MODIFICATIONS (FROM DECEMBER 1974)

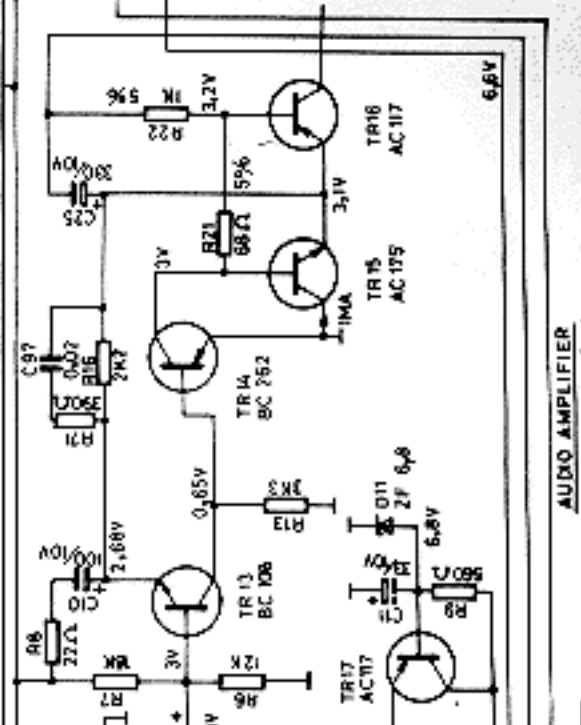
- C4 FROM 1μF TO 0.04μF
- R71 10T RESISTOR FROM JUNCTION OF L7/C43 TO POSITIVE CHASSIS
- C39 FROM 470μF/10V TO 33μF/10V
- R72 1K RESISTOR FROM TAP OF L2 TO POSITIVE CHASSIS
- ADDITION OF C92 33μF/10V CAPACITOR ACROSS THE METER
- R62 2K2Ω NOW BECOMES 1KΩ
- R63 100Ω NOW BECOMES 1KΩ
- C45 33μF/10V NOW BECOMES 1μF/10V
- C50 AND C62 NOW PLACED UNDER THE CIRCUIT BOARD AND NOT ON THE COMPONENT SIDE

- C75 - C80 2200 pF SERIAL N°s 0001 TO 0100 ONLY
- C80 2.5 TO 6 pF SERIAL N°s 0001 TO 1100 ONLY
- C32 7-35 pF (AND C28 NOT FITTED) ON EARLY MODELS
- VALUE OF R40 ON EARLIER MODELS:-
- A11K5 WITH METER TYPE KISHO Y04 600
- B13K9 WITH METER TYPE TOYO MUISSEN V81
- C17 ADJUSTING CAPACITOR

APPLICABLE TO SERIAL N°s 0001 TO 0100 ONLY

NOTE: TRANSISTORS TR1-TR2 & TR18 WERE BF 121 & BF 125 ON EARLIER MODELS.
